# Rezoning Application:

### MM 22-0884

**Development Services Department**

# 3.0 TRANSPORTATION SUMMARY (FULL TRANSPORTATION REPORT IN SECTION 9 OF STAFF REPORT)

2.3 Proposed Site Plan (partial provided belowfor size and orientation purposes. See Section 8.0 for full site plan)

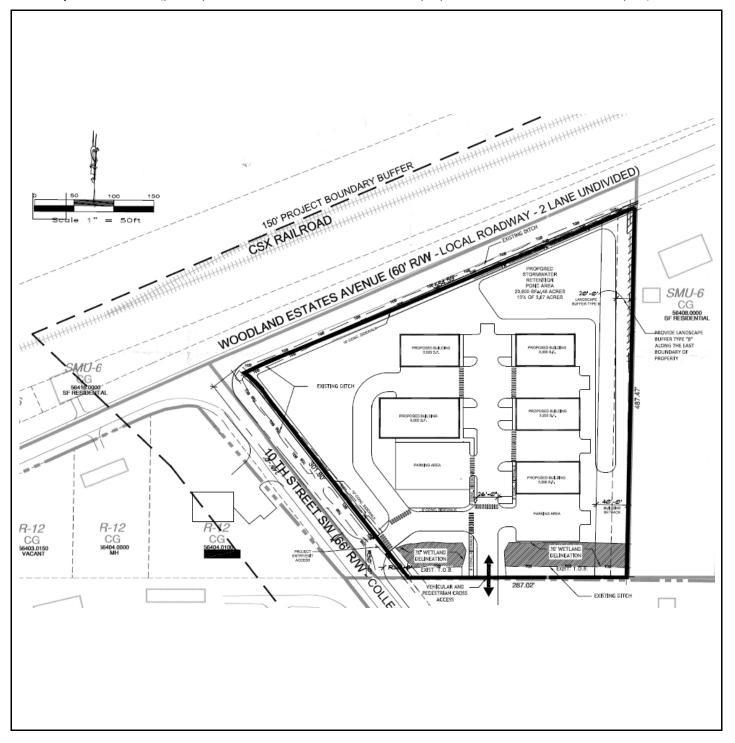
Prior to site plan certification, the applicant shall complete the following:

- Revise Proposed Use "Contractor's Office and General Office, General Office does not include Medical Office Uses" to "Professional Services, Professional Offices and Contractors Offices".
- Revise the "40-ft. building setback" shown as measured from the eastern property boundary to be shown from the additional 2 feet of setback for every foot of height over 20 feet setback.

Project Site Concept Plan

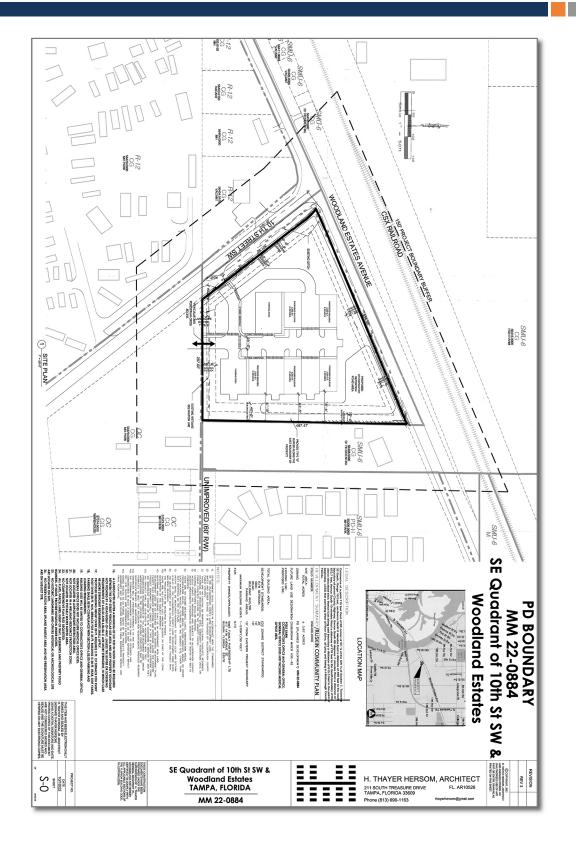
The applicant is requesting a design exception to construct +/-850 feet of sidewalk on the east side of 10<sup>th</sup> St., from Woodland Estates Ave. to US Hwy 41, in lieu of improving the roadway to standard. See the Design Exception request section below for additional detail.

The developer will be required to construct a sidewalk along the entirety of the 10<sup>th</sup> St. and Woodland Estates Ave. frontage per LDC, Sec. 6.03.02. Staff notes that the applicant has opted to construct a 10-ft wide multi-use path instead of a 5-foot wide sidewalk along the 10<sup>th</sup> St. frontage as part of the Design Exception process discussed below in greater detail.

Hillsborough County TS-7 Typical Section

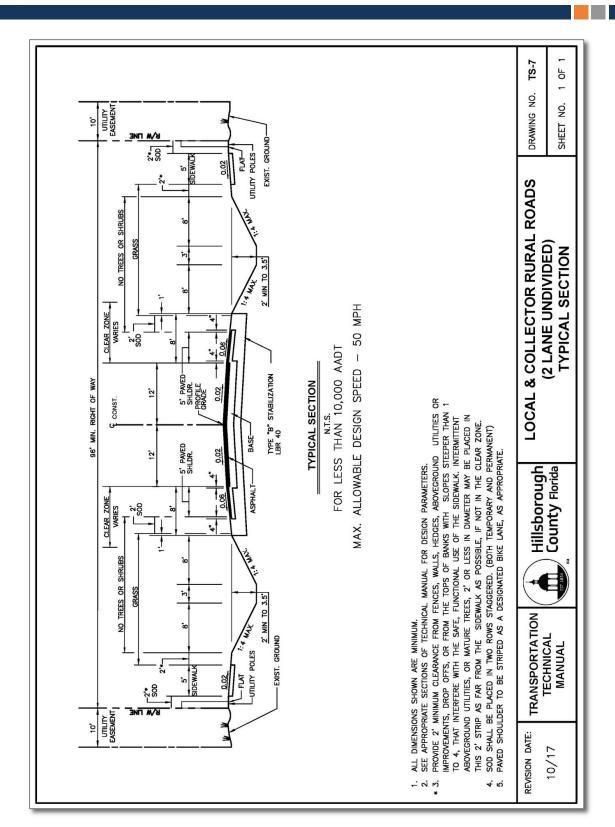
The deviation from County TS-7 standards in regard to the lack of sidewalks on both sides of the road is a significant concern in regard to planned development in close proximity to the commercially oriented corridor of US Highway 41. Therefore, the Applicant proposes to construct  $\pm$  850 feet of 10' multi-use path on the east side of  $\pm$  10th Street between Woodland Estates Avenue and U.S. Highway 41, including within the  $\pm$  300 foot project site frontage, as conceptually shown in **ATTACHMENT H**. In addition, the project will construct a typical 5 foot sidewalk along Woodlawn Estates Avenue within the  $\pm$  550 foot project site frontage.

**Connection Spacing Diagram**

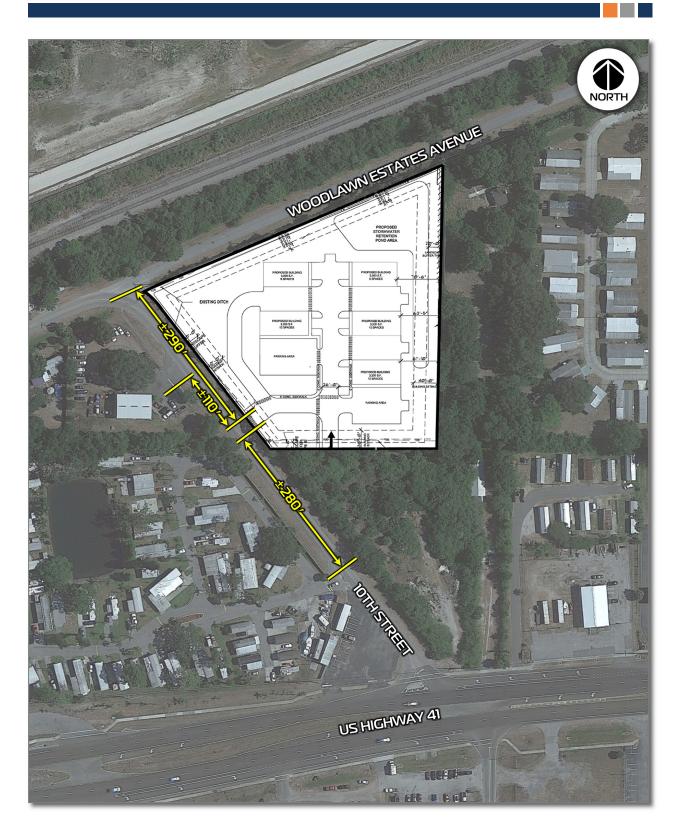
THERE IS AN UNREASONABLE BURDEN ON THE APPLICANT as the subject project site driveway connection to 10<sup>th</sup> Street is planned for construction at the southern boundary of the site, as far from the auto repair facility driveway as possible, while still providing access to 10<sup>th</sup> Street; noting that pursuant to LDC §6.04.03.I, "where Non-Residential development abuts Collector/Arterial and Local roads primary driveway connections shall be at Collector/Arterial roads and Local roads shall be use for secondary access." Woodlawn Estates Avenue is functionally classified as a local roadway, and thus access to this road rather than 10<sup>th</sup> Street is inconsistent with the requirements of the referenced code section. Therefore, approval of this Administrative Variance is necessary such that an unreasonable burden is not unduly imparted upon the applicant.

<u>WITHOUT THE ADMINISTRATIVE VARIANCE, REASONABLE ACCESS CANNOT BE PROVIDED</u> as the subject site access driveway connection is planned for construction in the best location possible while still providing access to 10<sup>th</sup> Street, where access to 10<sup>th</sup> Street rather than Woodlawn Estates Avenue is a requirement of LDC §6.04.03.I. *Therefore, approval of this Administrative Variance is necessary to provide reasonable access to the project.*

BASED ON THE INFORMATION PROVIDED BY THE APPLICANT, THIS REQUEST IS HEREBY APPROVED.
